Sunnica Energy Farm Consultation on proposed changes

6 June to 6 July 2022

Introduction

Change 3

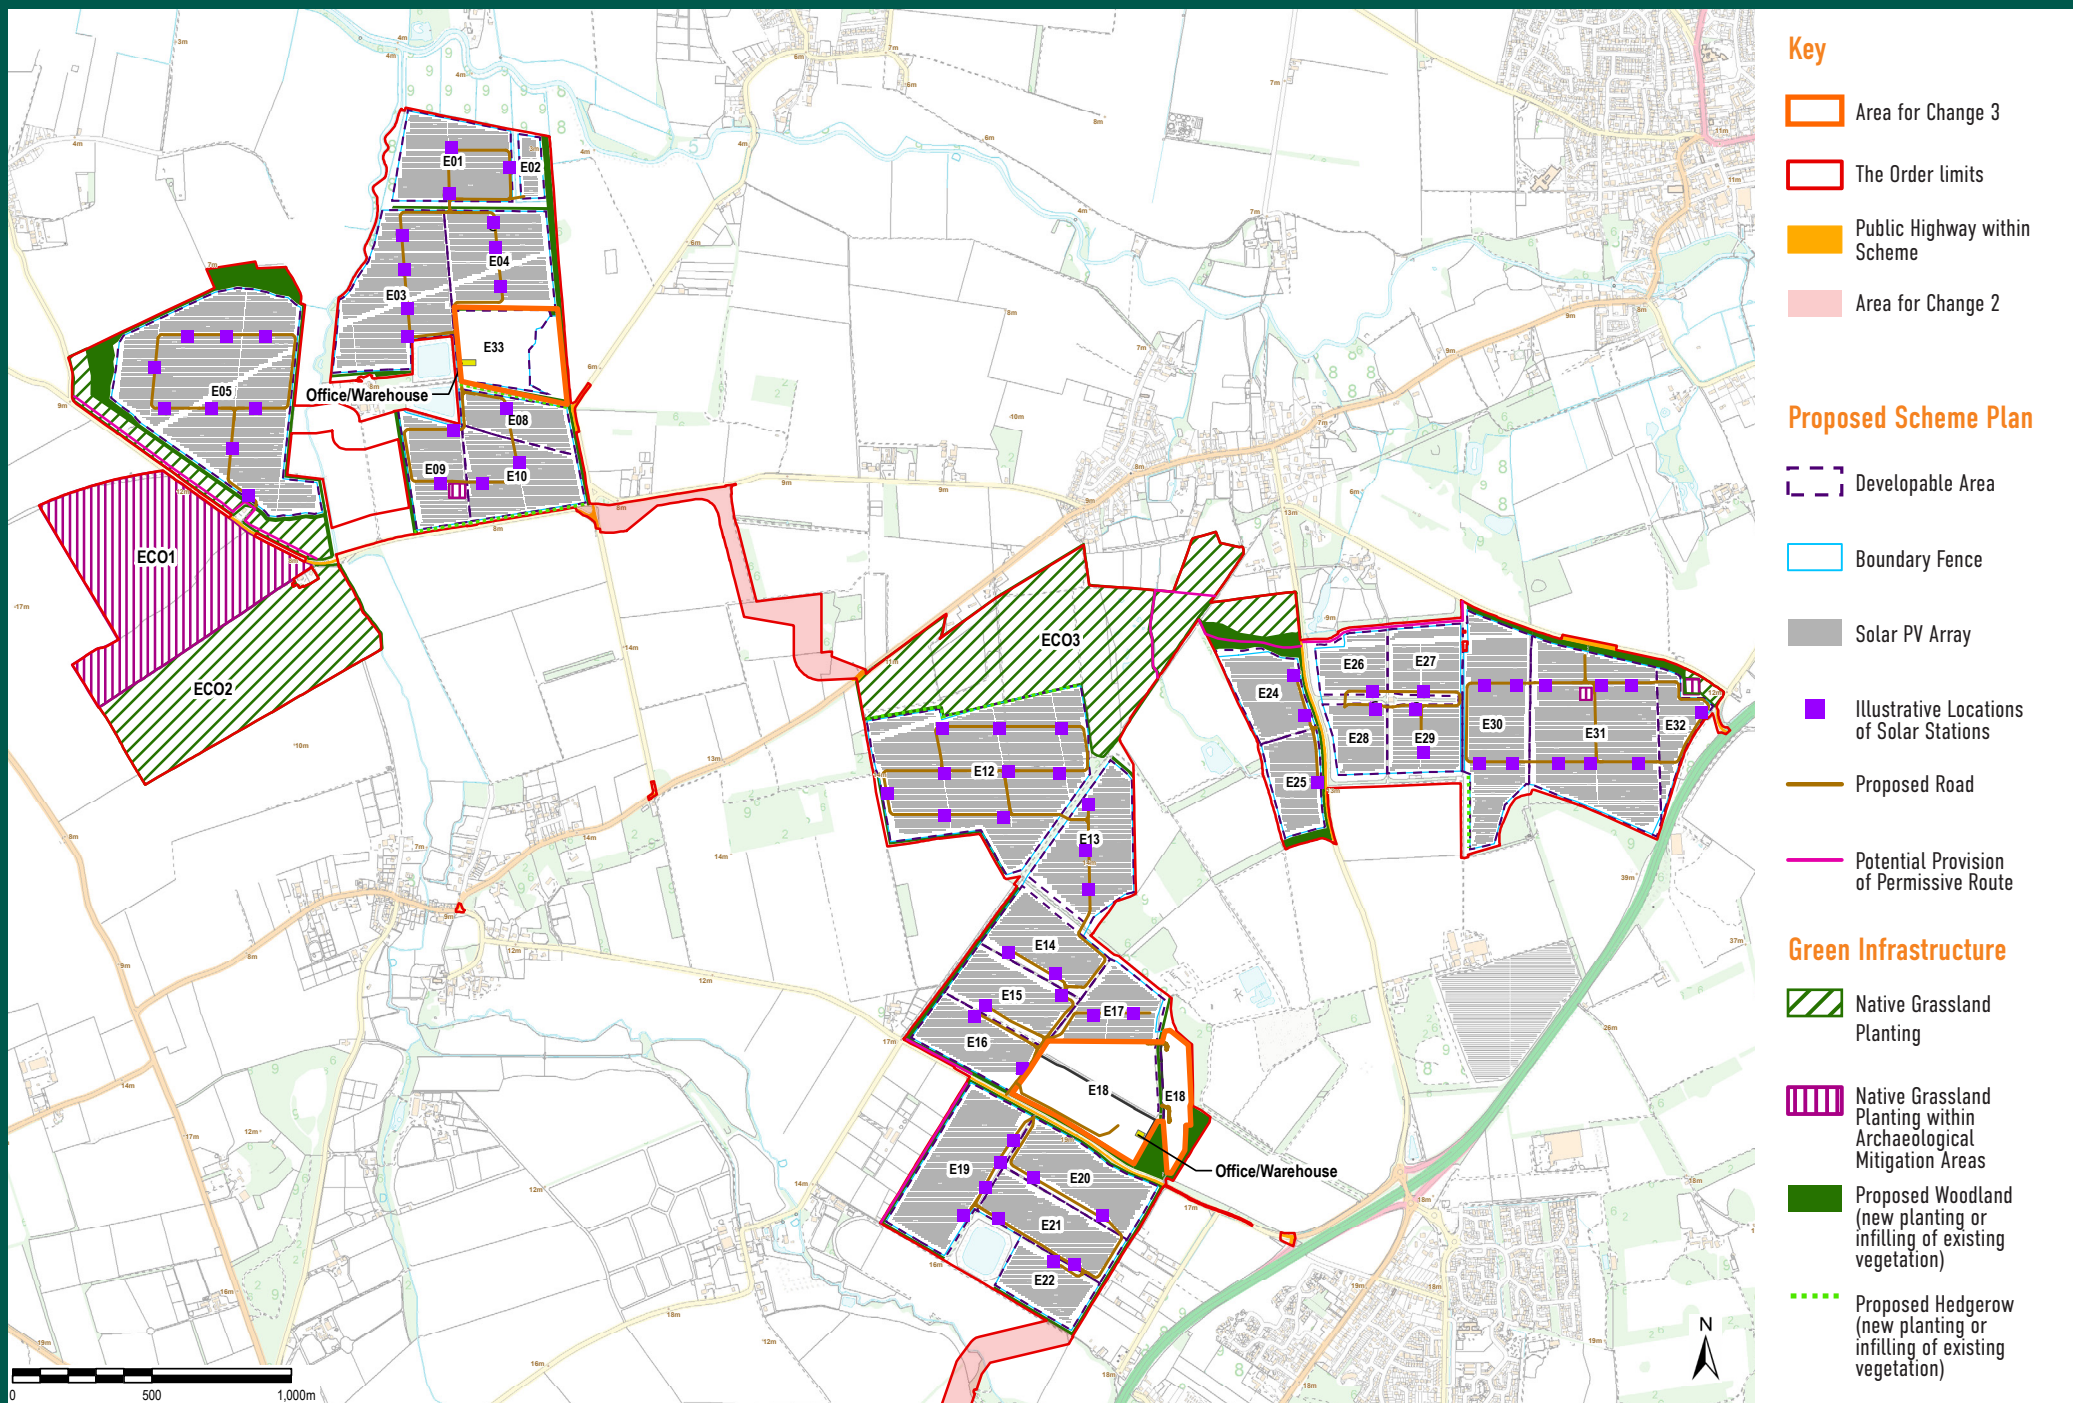
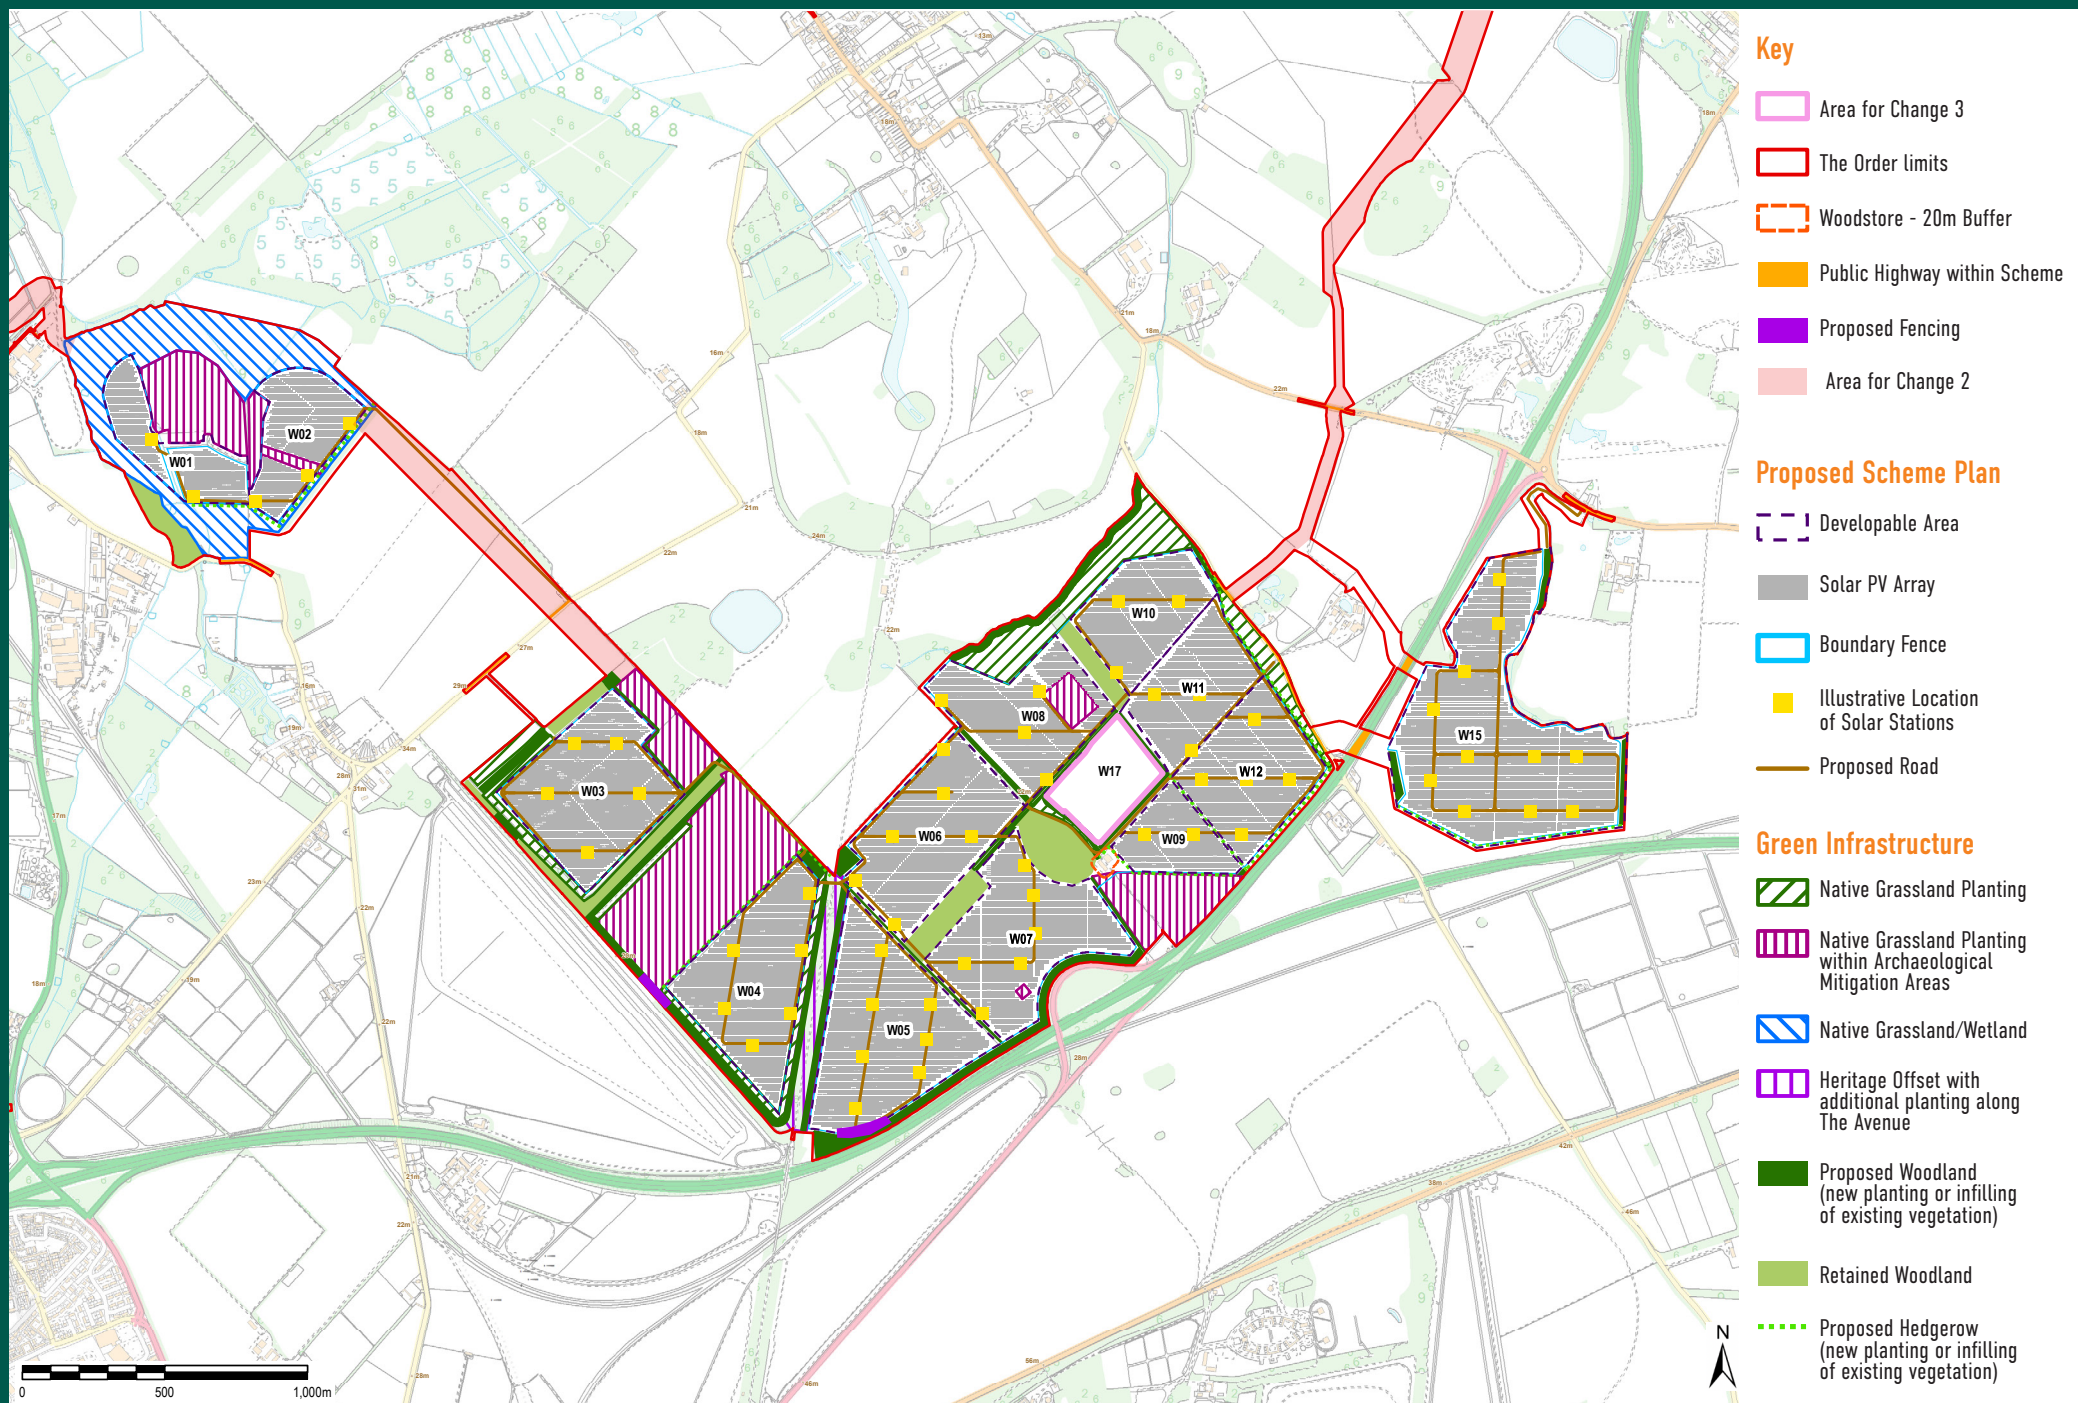
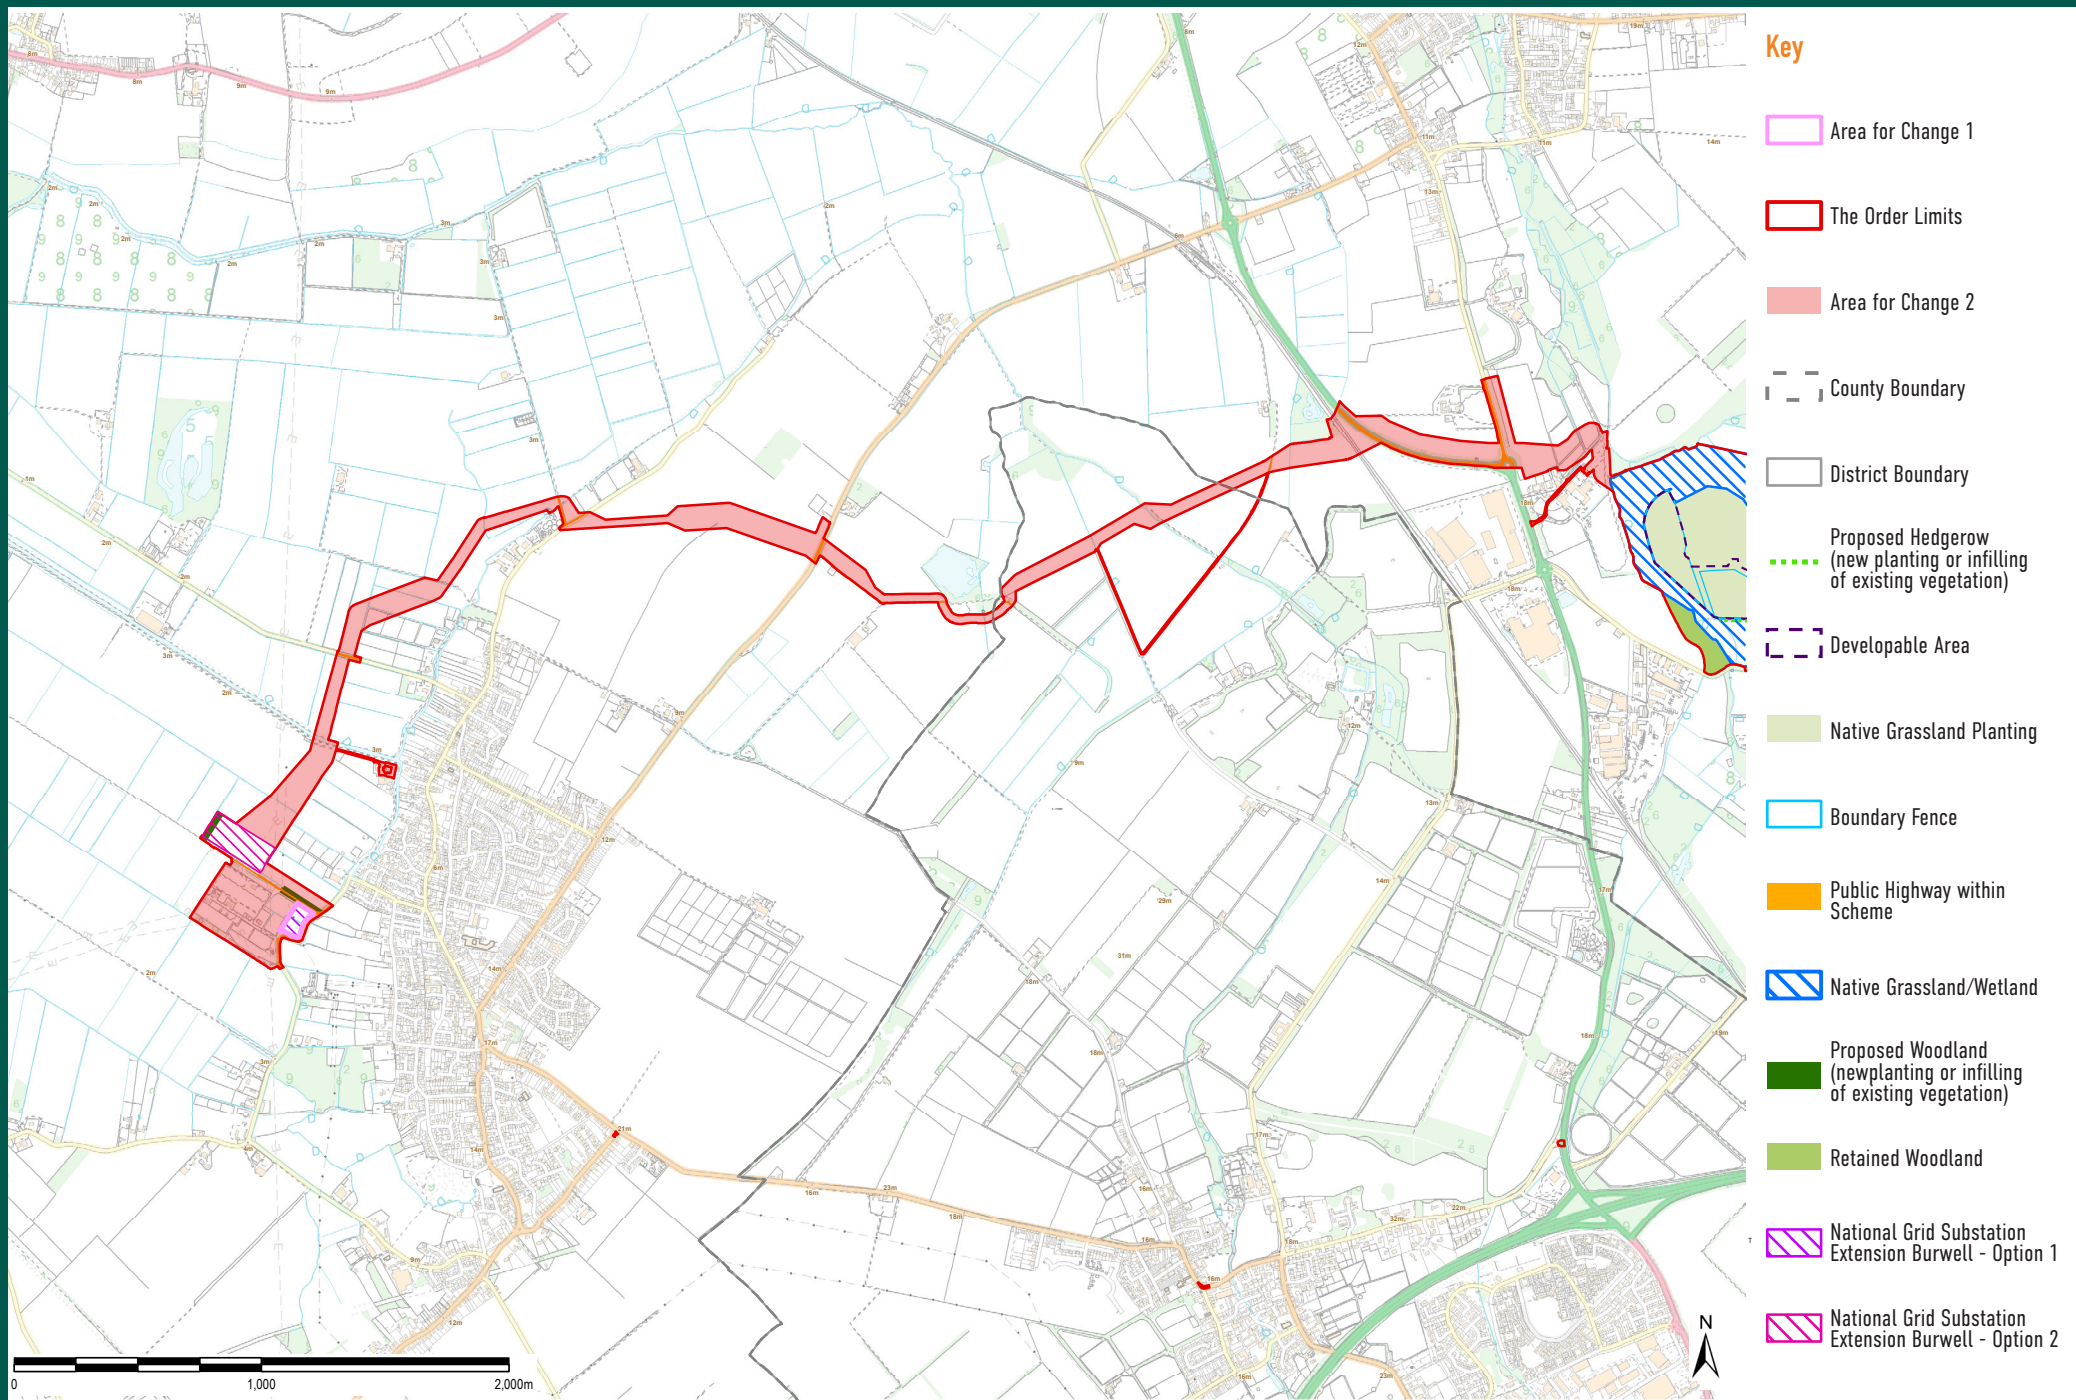
Change 3: Option to allow for additional electrical infrastructure to be added to the substations referred to in the Application at Sunnica West A, Sunnica East A and Sunnica East B. The change would not involve making the substations any larger than was included in the Application.

If Option 3 is to proceed, the substations at Sunnica West Site A, Sunnica East Site A and Sunnica East Site B will need to change in terms of their electrical configuration and therefore their general arrangement and layout would also be different but within the parameters assessed in the Environmental Statement submitted as part of the DCO application. This is owing to the introduction of a 400KV/ 33kV transformer in place of the 132kV/33kV transformers that would be required under Options 1 and 2. A shunt reactor would also need to be introduced at Sunnica East Site B.

Option to allow for additional electrical infrastructure to be added to the substations referred to in the Application at Sunnica West A, Sunnica East A and Sunnica East B. The change would not involve making the substations any larger than was included in the Application.

No amendments will be required as the developable area of, and works required at, each substation will remain the same. Amendments will be required to Schedule 1 of the Draft Development Consent Order [APP-019] to allow for the addition of shunt reactors within the substation areas.
